**BEFORE THE INDEPENDENT HEARING PANEL APPOINTED BY THE  
QUEENSTOWN LAKES DISTRICT COUNCIL**

**UNDER** the Resource Management Act 1991 (RMA)  
**IN THE MATTER** of the Te Pūtahi Ladies Mile Plan Variation in accordance  
with section 80B and 80C, and Part 5 of Schedule 1 of the  
Resource Management Act 1991.

**STATEMENT OF EVIDENCE OF MICHAEL [XX] LOWE  
29 September 2023**

Figure 3: Density study 70 dwellings per hectare

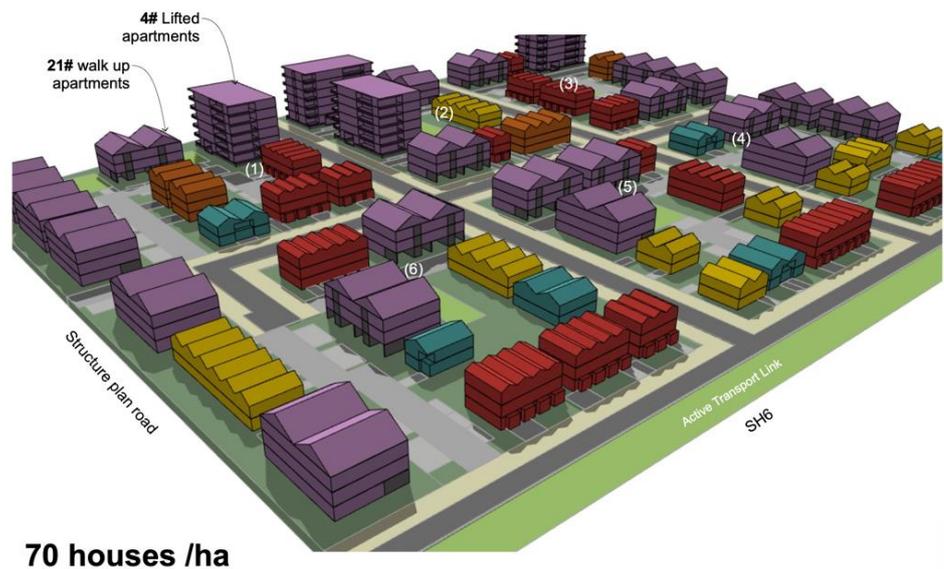
- 50 The proposed height restriction overlay (refer Te Putahi Ladies Mile Structure Plan – Building Heights) and minimum building heights overlay intentionally responds to the surrounding site land features by positioning the tallest building mass closer to Slope Hill. In my opinion this is appropriate because it uses the large landscape backdrop of Slope Hill to reduce the building massing's relative scale, whilst achieving the desired outcomes in terms of density. Note as shown in Figure 3 the upper density requirements in the HDRP of 72 residential units per hectare likely results in a built form outcome with most buildings as 3 storeys. From a sunlight and shading perspective, this is a good outcome as only several 6 storey apartments would likely eventuate.

Figure 4: Proposed adjustment to building heights on the Western site boundary

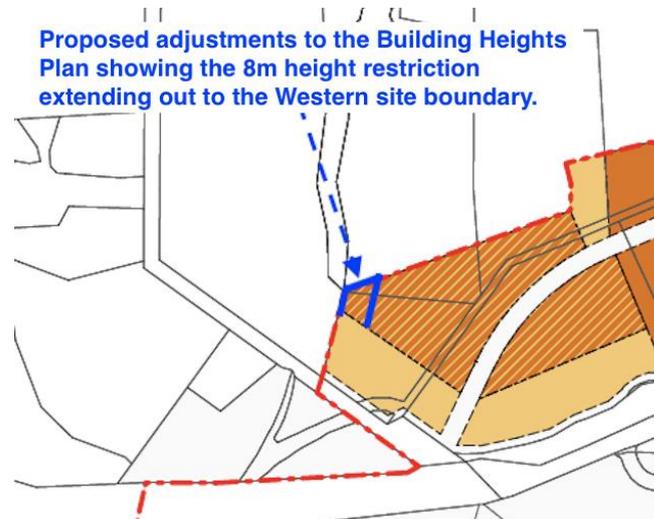
- 56 In response to Milstead Trust's (submitter 108) request to soften the zone building height transition between the HDRP and Glenpanel Precinct by increasing building height on the Eastern end of Glenpanel, I consider that this can be addressed through the consenting assessment process. I recommend that the assessment matters be updated to include greater requirements for new development to responds sensitively/ enhances the heritage qualities of the Glenpanel precinct in terms of built form visual dominance.
- 57 I agree in part with GW and SE Stalker (submitter 71) request for more height control against their eastern boundary. The currently proposed

13m building height overlay abutting their land could lead to a more than minor height differential and associated visual dominance impacts on the submitters' land. In response, I consider an appropriate mitigation is to wrap the 8m height restriction along the entire Western edge of 'Sub area A' to more appropriately smooth the transition to the neighbouring Rural Amenity Zone. This will be further mitigated by the landscape buffer in the TPLM Variation Structure Plan.

Figure 5: Proposed reduction in building heights (reduced down from 13m to 3 storey maximum)

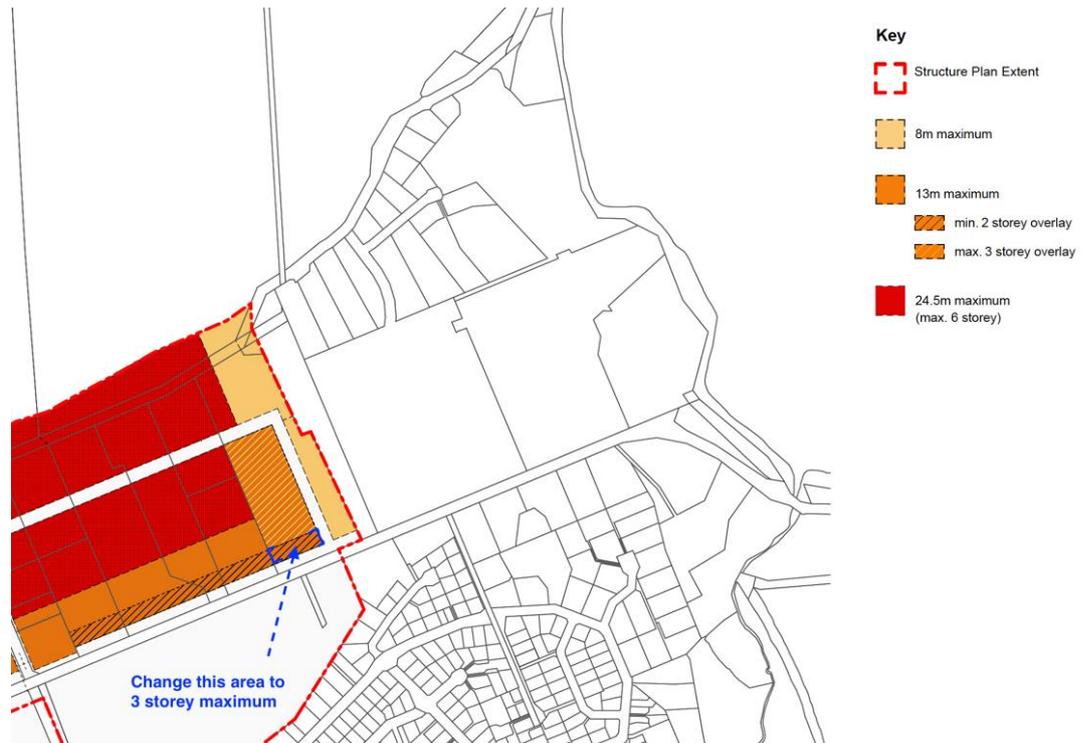
59 In response to Shane Pratley (submitter 41) request to reduce building heights and other submitters' requests to reduce visibility of development. I consider it would be appropriate to include further strengthening of the overall transitional stepping down in building heights towards the Eastern rural boundary by extending the maximum 3-storey building height restrictions deeper into the site. This change ensures a lower building height at the Eastern entrance threshold of the site.

Figure 6: BRA sought by Corona Trust (submitter 99) shown in blue

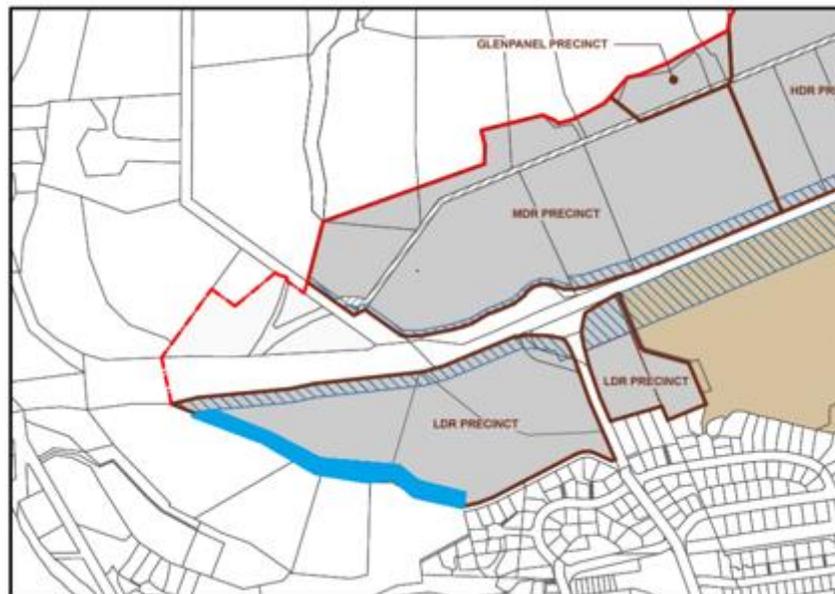
- (a) Kim Netzler (submitter 50) increase BRA to 50m from SH6 and ensure planting screens the entire complex;
- (b) Flightplan 2050 (submitter 84) increase BRA south of SH6 to 75m for emergency plane landings;
- (c) Corona Trust (submitter 99) add a new setback in sub-area H2 no less than 20 metres (shown in Figure X below);

- 65 In my opinion, subject to where I have specifically addressed changes in response to submissions in paragraph 68 below, I support retaining the setbacks and BRAs shown in the notified version of the TPLM Variation Structure Plan for the following reasons.

Figure 8: Proposed design amendment to the structure plan

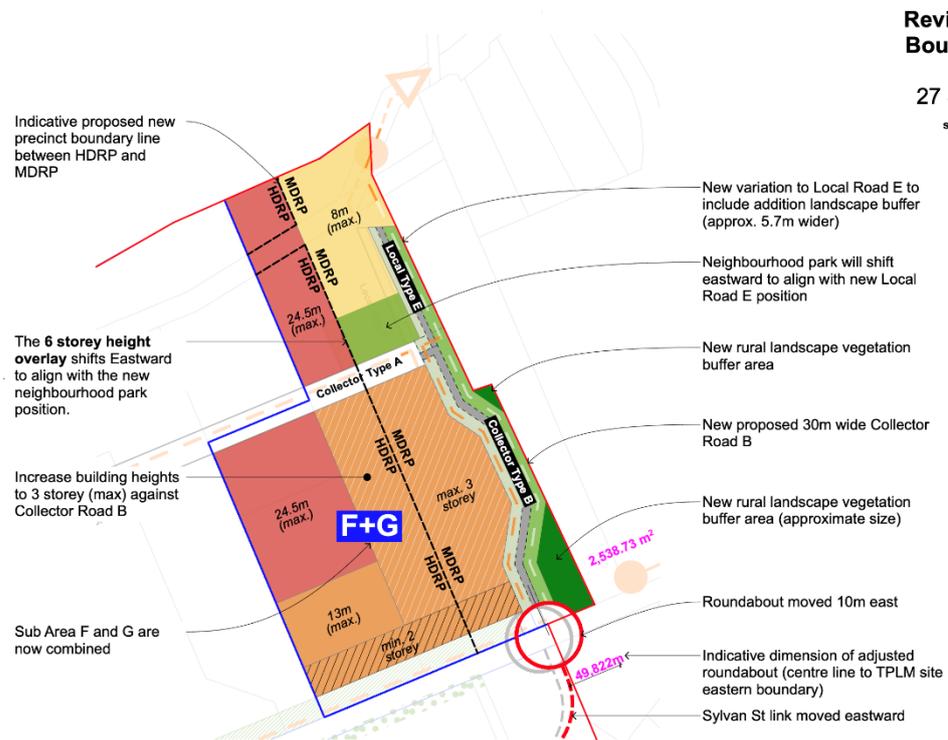
- 73 David Finlin (submitter 101) seeks a wider dimension to the land be included in Sub Area G adjoining the TPLM eastern boundary to make it more usable. Note that this area of the site demarcates the boundary of the proposed urbanised built environment. As such it is an area of interest to several other submitters regarding how future development will affect the surrounding rural character, and the desire for greater landscape control and screening.

- 74 I investigated multiple alternative design approaches to this area that could achieve the right balance in regard to their likely urban design outcomes in terms of improved relationship of the site edge with the rural land, quality of landscape screening, and development efficiency for the land owner.
- 75 My recommendation is to shift Collector Road B and Local Road E eastward ~6m (at the shortest point) up to 35m (at the furthest point) to be hard up against the eastern site boundary. In addition, I recommend that the Collector Road B and Local Road E cross section conditions be updated at this location to include a well-layered landscape planted buffer as part of the road corridor. Refer to **Appendix A** for a larger image.

- 76 I consider these proposed changes will result in positive urban design outcomes for the following reasons:
- The new road position logically demarcates the urbanised edge of TPLM with a public.
  - The changes will ensure well-designed landscape edge to the adjacent rural zone that will give good vegetation screening with an attractive layering of planting and trees of a scale respectable

- 77 The consequential effects of the proposed change in design results in the following amendments to the structure plan:
- (a) The neighbourhood park moves eastward to stay connected to the local road.

- (b) The SH6 roundabout shifts eastward. This is indicatively shown in its position in figure 7 noting that likely contour constraints prevent it shifting further east.

Figure 9: Plan diagram of a zero-lot house - for reader clarity purposes.

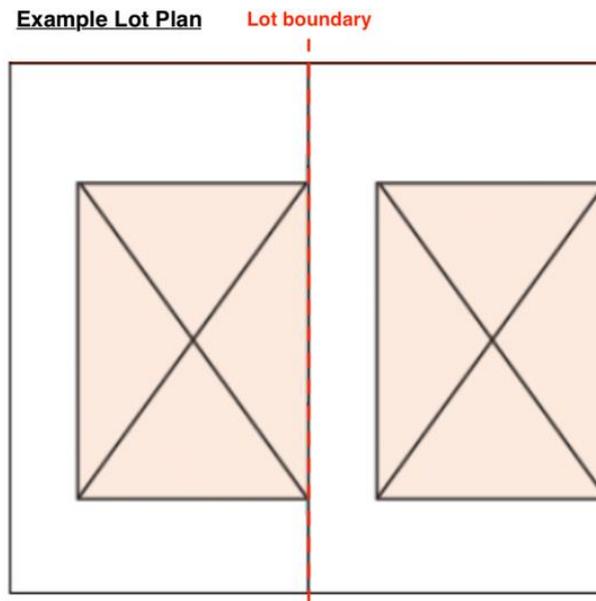
- 96 I consider that the following amendments to the bulk and location rules are appropriate on the bases that:
- (a) The proposed rules were unclear on use of Zero-lot housing typologies where one side of buildings are built on the title boundary (see image below).

- (b) I clarify that zero-lot houses are not allowed on the basis they undermine the desired outcomes of the 1.5m side yard rule as described in paragraph 90.
- (c) I agree with Ladies Mile Property Syndicate (submitter 77) and the Sanderson Group and Queenstown Commercial (submitter 93) request to reduce/ simplify the HDRP side-yard boundary setbacks. On reflection a setback dimension of 1.5m (previously 3m) is sufficient to enable access around the building and will be the same as the proposed MDRP rule.
- (d) I agree with the Sanderson Group and Queenstown Commercial's (submitter 93) concern for the landscaped permeable surface requirement in the commercial are being too restrictive in recognition that some surface parking will need to be accommodated in this precinct. My recommendation is to reduce this to 15%.
